RE: Technically Complete Determination  
ExxonMobil Refining & Supply Company  
Rain Basin 2  
AI-2638/ GD-033-0596/ P-0273  
PER20020001  
East Baton Rouge Parish

RE: Louisiana Solid Waste Permit Mandatory Modification Document  
Rain Basin No. 2  
ExxonMobil Refining & Supply Company  
Facility No. GD-033-0596  
Solid Waste Permit No. P-0273  
Agency Interest Number 2638  
Activity Number PER20020001  
Baton Rouge Refinery  
Baton Rouge, East Baton Rouge Parish, Louisiana

RE: Notice of Deficiencies  
ExxonMobil Refining & Supply  
Solid Waste Mandatory Modification/Permit Renewal Application  
Agency Interest #2638  
Activity Number PER20020002  
East Baton Rouge Parish

**Notice of Deficiencies Responses****Updated Louisiana Solid Waste Permit Mandatory Modification Document****Rain Basin No. 2****ExxonMobil Refining & Supply Company****Facility No. GD-033-0596****Solid Waste Permit No. P-0273****Agency Interest No. 2638****Activity No. PER20020002 / PER20020001****Baton Rouge Refinery****Baton Rouge, East Baton Rouge Parish, Louisiana****Technical Review****LDEQ Comment:**

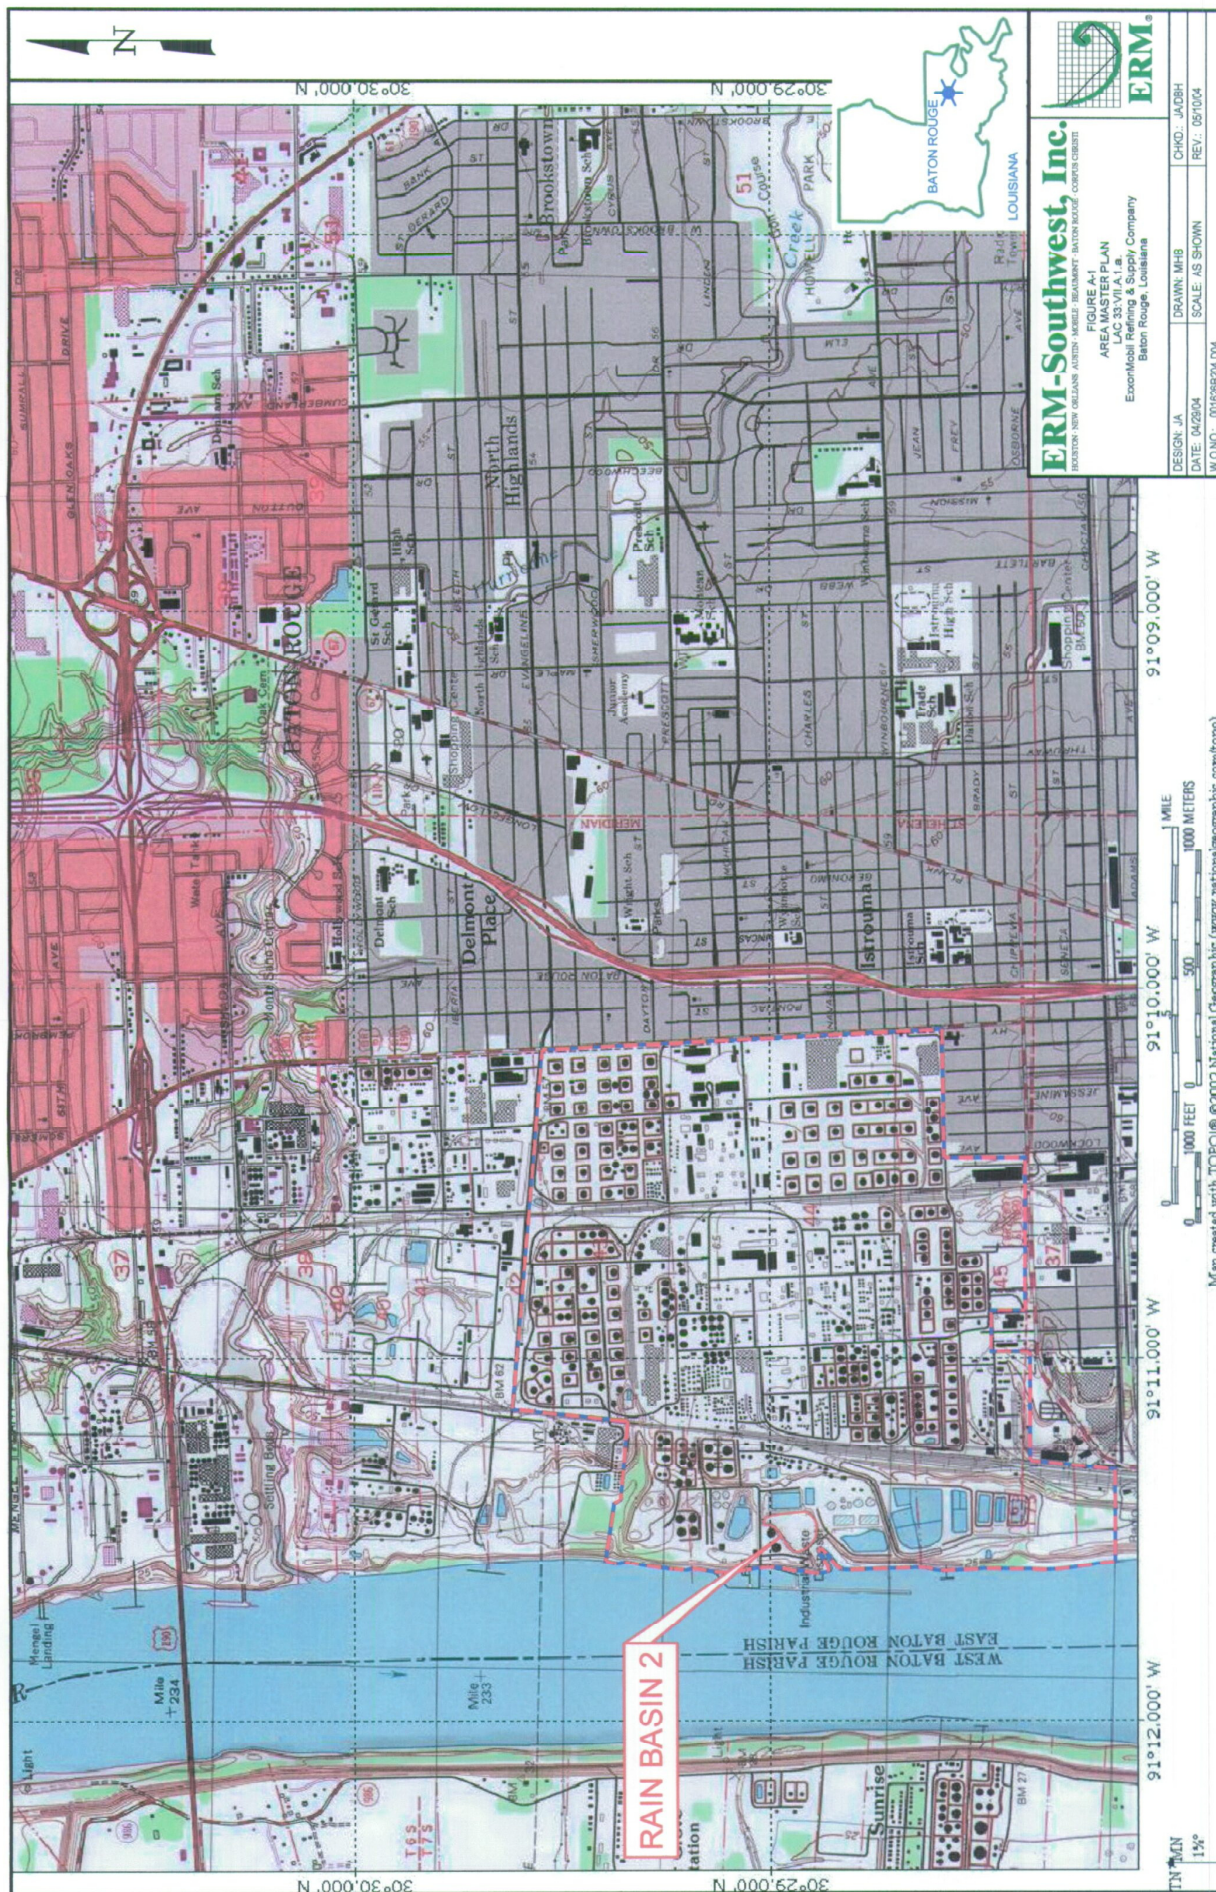
- 521.A.1.a Figure A-1 does not show the drainage flow patterns in the vicinity of Rain Basin 2.
- 521.A.1.d The aerial photograph included does not show the location of Rain Basin 2 or the 1-mile radius surrounding the facility.

Drainage flow patterns are indicated on Figure A-1. The topographic map presents surface contours indicating the drainage flow patterns. Additionally, facility stormwater is managed by the facility's sewer systems.

FIGURE D-1  
SOIL BORING LOCATIONS

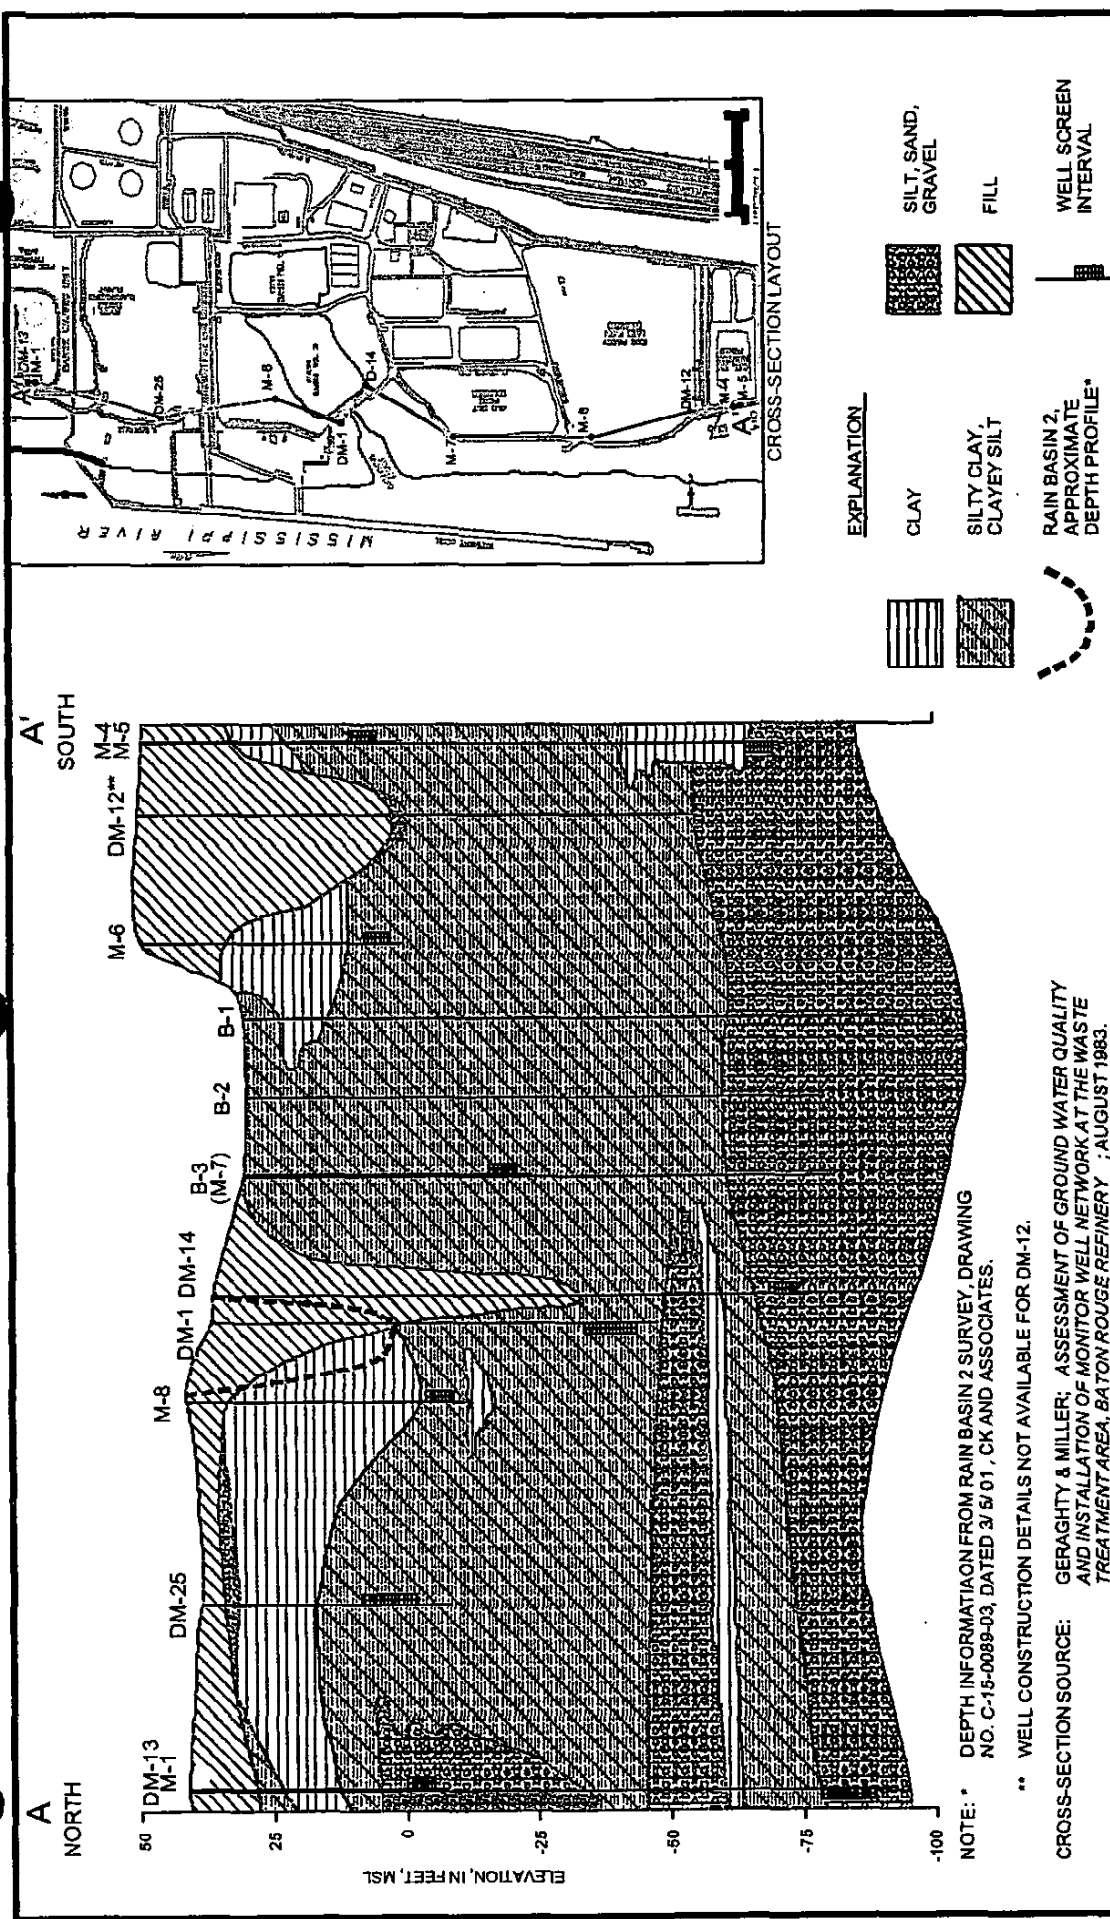
521.D.1.a Please provide geological cross-sections that incorporate all borings located in the vicinity of Rain Basin No. 2. Cross-sections should depict the monitoring well/piezometers, boring logs, and screen intervals. Please note that cross-

Two cross sections depicting the geology at Rain Basin No. 2, i.e., A-A' and C-C' have been revised to show monitor well-screen depth intervals. In addition, the depth profile of Rain Basin No. 2 has been added. Revised geological cross sections A-A' and C-C' are attached as figures D-1 and D-4, respectively.
